Application by National Highways for an Order Granting Development Consent for the Lower Thames Crossing Natural England's response to Deadline 5 Natural England User Code: 20034784

# Natural England's response to the Applicant's Air Quality Technical Note and Without Prejudice Assessment

Figure One. NVC map of the North Downs Woodland SAC.

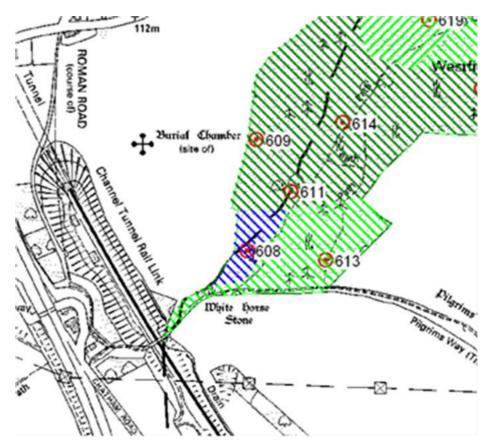
- 36. Our assessment of the woodland closest to the road is that it is a NVC "W8" woodland (ref no. 613, Fraxinus excelsior Acer campestre Mercurialis perennis woodland Primula vulgaris Glechoma hederacea sub-community) and agrees that it does not form part of the qualifying beech (W12) or yew (W13) NVC types. However, approximately 250m 260m away from the ARN (blue hatching on Figure One overleaf) there is an area of W12a woodland (ref no. 608 Fagus sylvatica (European beech) Mercurialis perennis sub community), which is regarded by Natural England to comprise the beech SAC feature. This feature should be considered in further assessment, as although it is located outwith the 200m distance from the ARN, it is sufficiently close that there could be >1% pollutant impact, and therefore LSE.

- 37. Lack of N-sensitive species within the applicant's site survey (para 4.3.11) does not imply that the area/site is not sensitive to further additions of nitrogen deposition (or ammonia/ NOx), as such species could be affected by the existing and historic pollution levels in the area. For example, British Bryological Society records (via the National Biodiversity Network Atlas) indicate evidence of 25 bryophyte species in the woodland from 2007, though there are no more recent records. A reduction in pollution (potentially delayed by the proposed development) could result in the reestablishment or establishment of more N-sensitive species as the site recovers, reflective of the qualifying features.
